Project	IEEE 802.16 Broadband Wireless Access Working Group < http://ieee802.org/16 >	
Title	A method of scanning neighbor BSs periodically	
Date Submitted	2004-06-07	
Source(s)	Kihyoung Cho, Yongho Kim, Changjae Lee LG Electronics, Inc. 533, Hogue-1dong, Dongan-gu, Anyang-shi, Kyongki-do, Korea	Voice: 82-31-450-2945 Fax: 82-31-450-7912 [mailto:kiyoung@lge.com, ronnykim@lge.com, cjlee16@lge.com]
Re:	This is a response to a Call for Comments IEEE802.16e Handover Adhoc.	
Abstract	In this contribution, a method of supporting periodic scanning is provided.	
Purpose	This document is submitted for review by 802.16e Working Group members	
Notice	This document has been prepared to assist IEEE 802.16. It is offered as a basis for discussion and is not binding on the contributing individual(s) or organization(s). The material in this document is subject to change in form and content after further study. The contributor(s) reserve(s) the right to add, amend or withdraw material contained herein.

A method of scanning neighbor BSs periodically

Figure E.1—Example BS advertisement and scanning (without association) by MSS request

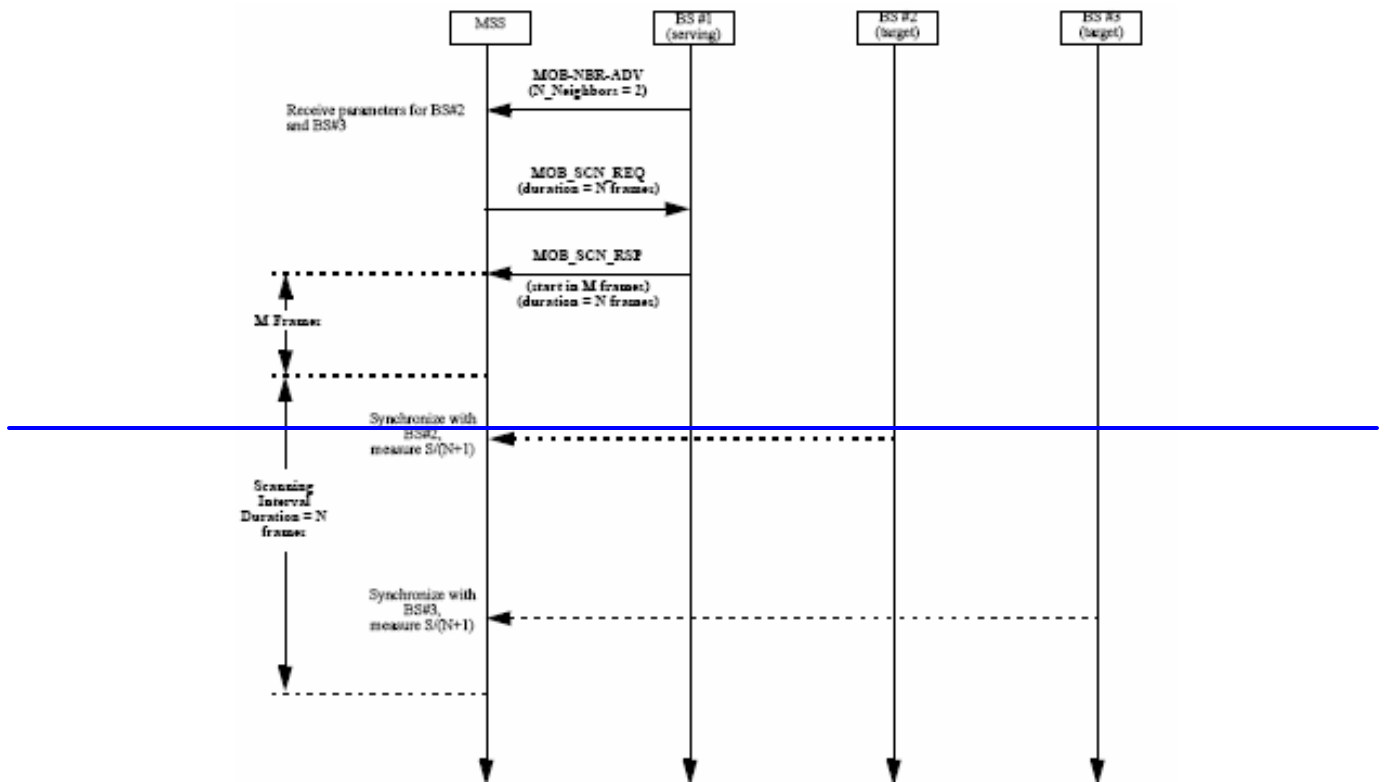
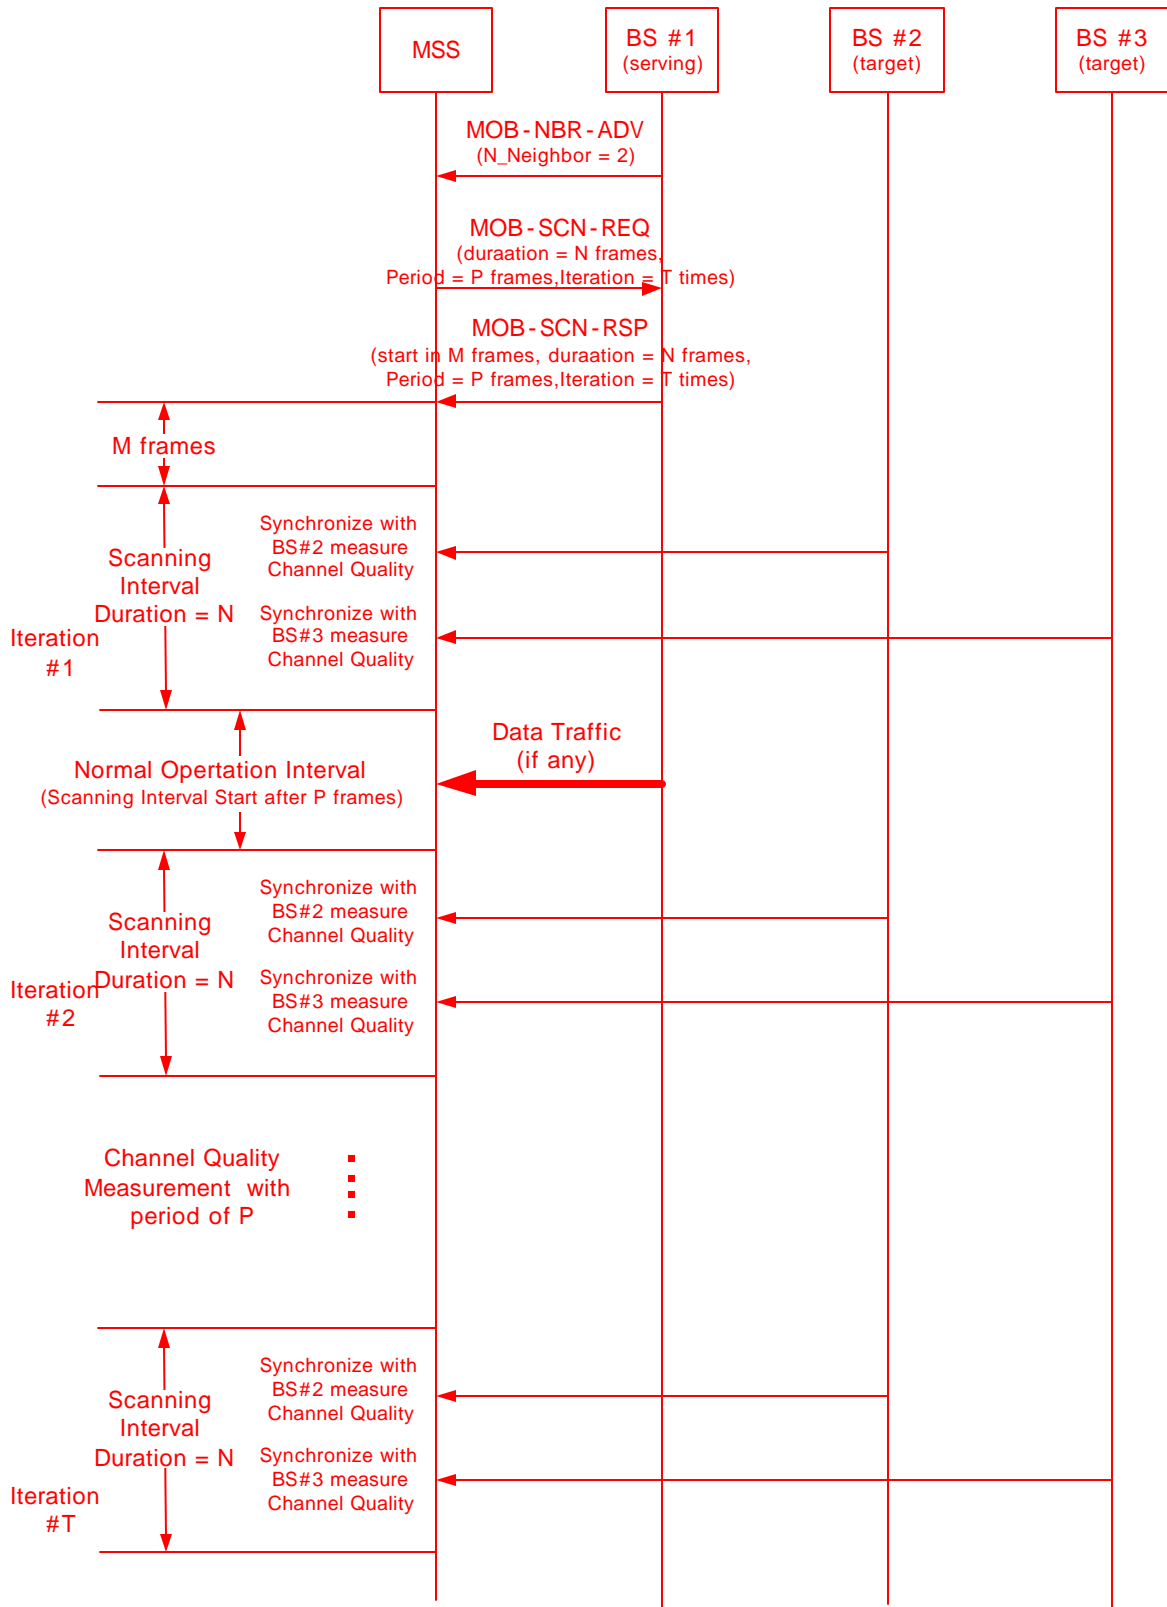
[Modify the Figure E.1– Example BS advertisement and scanning (without association) by MSS request]

The following figures describes the messages flow for neighbors advertisement and scanning of neighbors by the MSS request, BS request and periodic scanning of neighbors during hand-over.
